ALERT SERVICE BULLETIN

NO. 214ST-01-83

MODEL AFFECTED: 214ST

SUBJECT: MAGNETIC BRAKE P/N 204-001-376-103, ONE TIME INSPECTION OF.

FIGURE 1

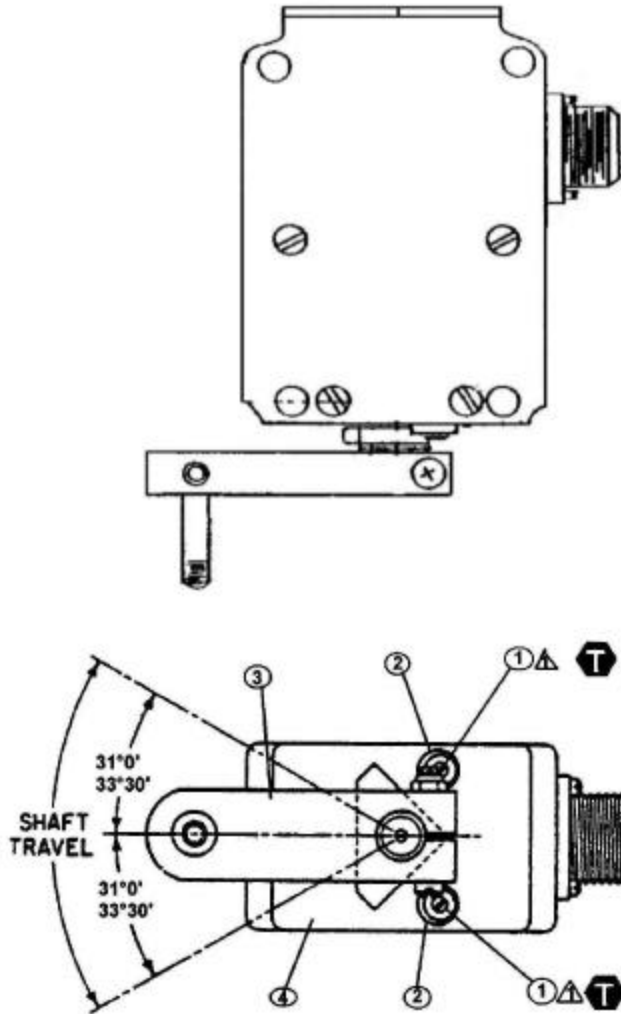
Bell Helicopter has recently received a report that magnetic brake P/N 204-001-376-003 adjustable stop screws P/N MS51959-3 had backed out which limited the travel of the arm assembly. Investigation revealed the stop screws had been installed without the proper adhesive. A similar design, 204-001-376-103, is used on Model 214ST helicopters. These Magnetic Brakes were manufactured by Memcor Truohm, Inc. under their P/N MP498-103. P/N 204-001-376-103 Magnetic Brake made by other manufacturers are not affected by this bulletin.

If the inspection reveals that screw(s) (1) has disengaged, inspect arm assembly (4) for mechanical damage created by screw(s) (1). If mechanical damage is found, the depth shall not exceed 0.030 inch (0.762 mm). Acceptable damage may be smoothed and treated in accordance with the Standard Practice Manual Chapter 3 for Chemical Film. If damage is greater than 0.030 inch (0.762 mm) contact Product Support Engineering.

6. Remove screw(s) (1) and stop limit(s) (2) from magnetic brake (4).

7. Clean dried adhesive from magnetic brake (4) screw holes and screw(s) (1) with compressed air.
8. Apply adhesive (C-320) to screw(s) (1) threads and install in magnetic brake (4) hand tight.
9. Adjust the stop limit(s) (3) to achieve the arm assembly shaft travel as per dimension in figure 1.
10. Once shaft travel is obtained, torque screw(s) (1) 5 to 10 in-lbs (0.56 to 1.12 mm).
11. Apply torque seal inspection ink to screws (1) and to stop limits (2).
12. Re-install anti-torque magnetic brake access panel.
13. Connect battery.
14. Make an entry in the helicopter historical records indicating compliance with this Alert Service Bulletin.

-  Bond screw with adhesive C-320
-  5 to 10 IN-LBS
(0.56 TO 1.12 Nm)
